Enersource Hydro Mississauga Inc.

**Application for electricity distribution rates and other
charges effective January 1, 2016.**

AMPCO's Final Submissions

Figure 1. Enersource's actual and proposed capital investment portfolio expenditures (2011-2021)

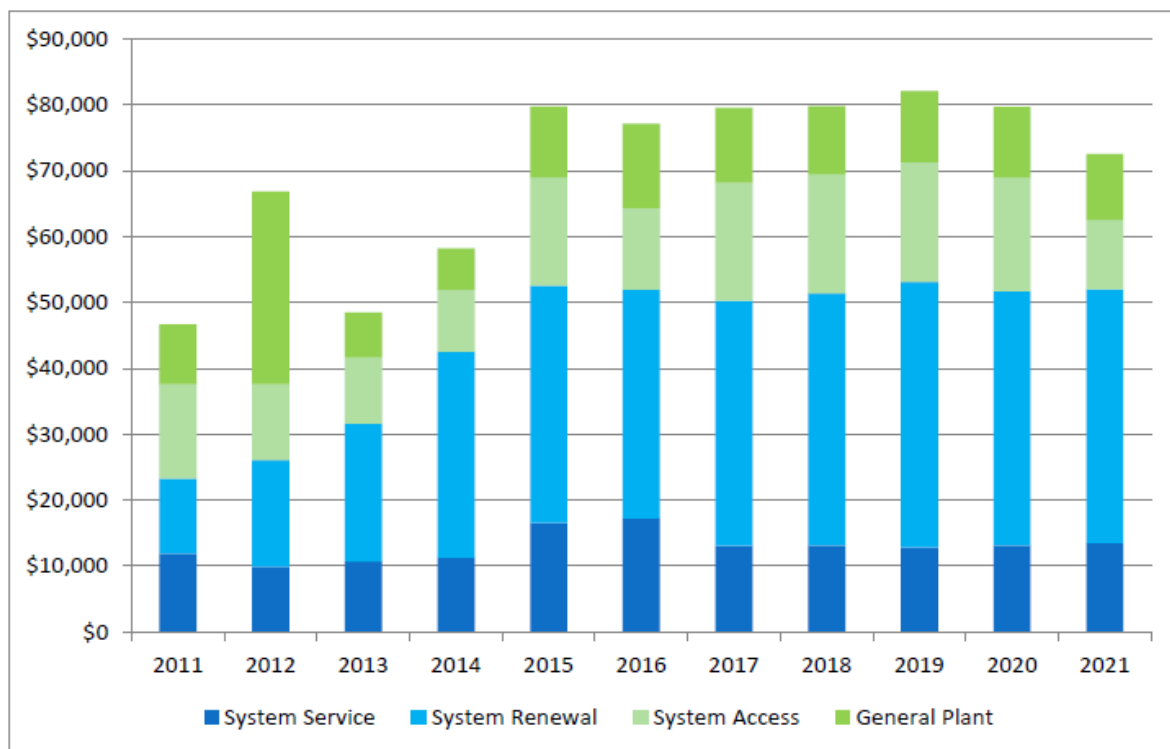
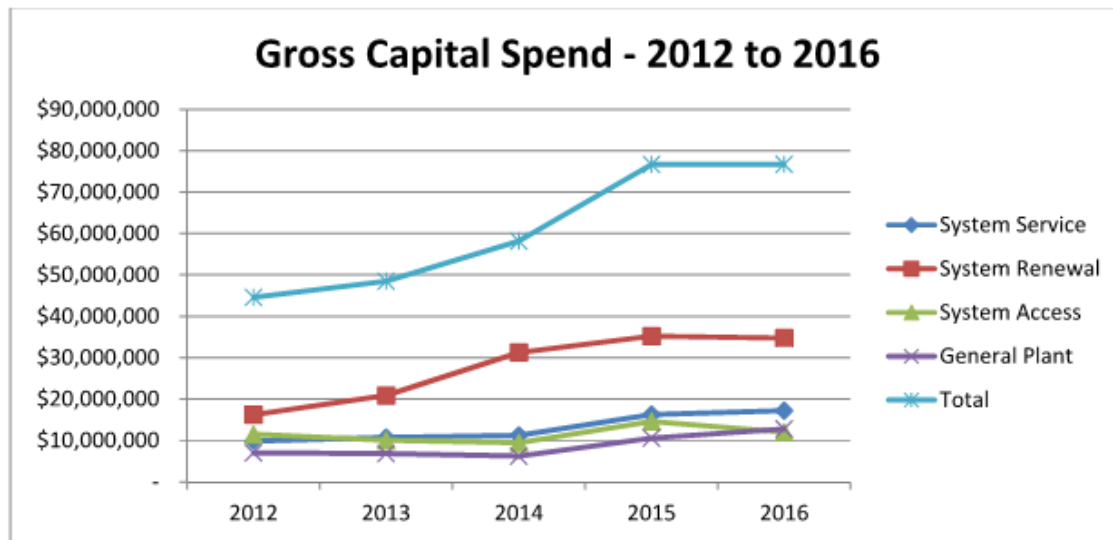
AMPCO's position is that Enersource has not adequately justified increasing its System Renewal spend by 60% over 2013 actuals, from \$46.173 to \$74.572. In AMPCO's view, Enersource's 2016 proposed asset renewal capital spend is at a pace and scope that exceeds the results of its most recent 2014 Asset Condition Assessment (ACA)⁸ which was used to develop the 2016 budget.
